Jean Fraser - Planner
City of Portland
Planning & Urban Development Department
389 Congress Street
Portland, ME 04101

January 17, 2014

Subject: Munjoy Heights
 Final Level III Site Plan – Conditions of Approval
 Comment Response Letter

STORM DRAIN, SEWER AND WATER TYPICAL TRENCH SECTION
NOT TO SCALE

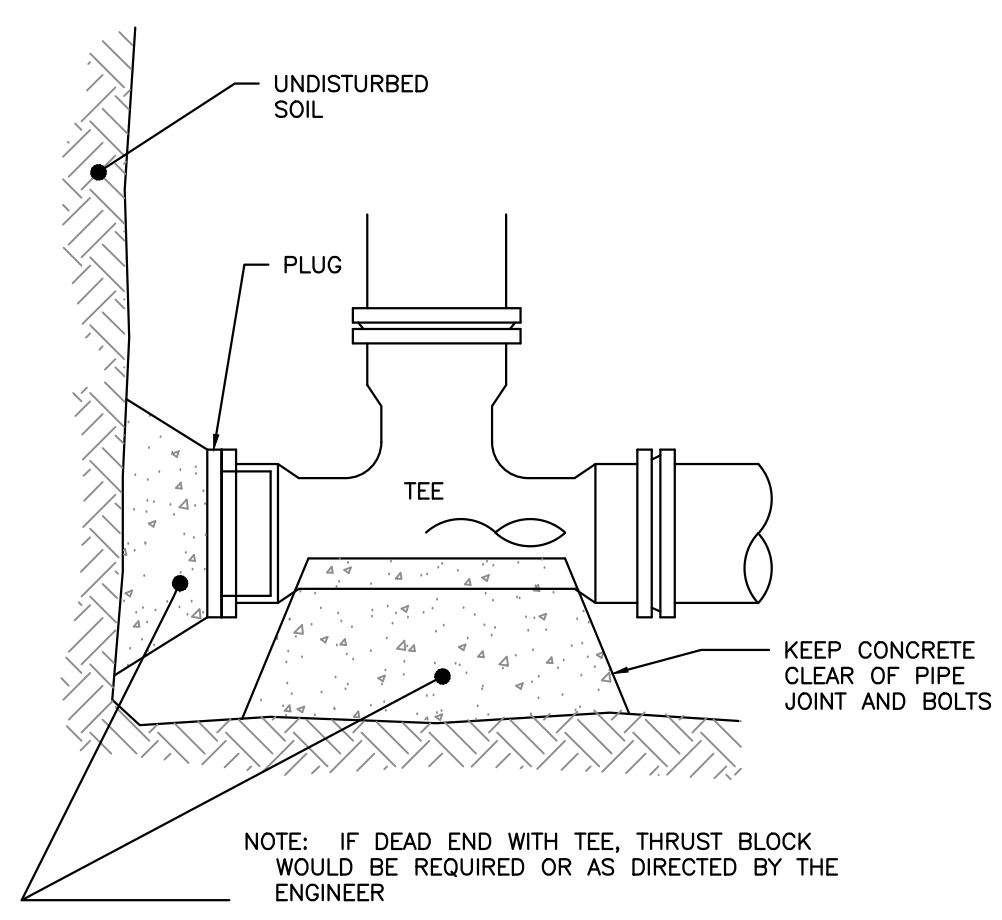
- 10) *Comment adequately addressed.*
 11) *Comment adequately addressed.*
 12) *The Applicant's response letter states that "All proposed trees within a 5' proximity of the sewer pipe will be planted at a depth no greater than 3' deep. Permeable landscape fabric will be used to create a root barrier around the sewer pipes". This requirement should be reflected on the Landscaping and Civil plans.*

Response – Note 5 was added to the Storm Drain, Sewer and Water Typical Trench Section on Sheet C-45 stating:

5. All proposed trees within 5' proximity of the sewer pipe shall be planted at a depth no greater than 3' deep. Permeable landscape fabric shall create a root barrier around the sewer pipes. Contractor shall coordinate with the landscape drawings."
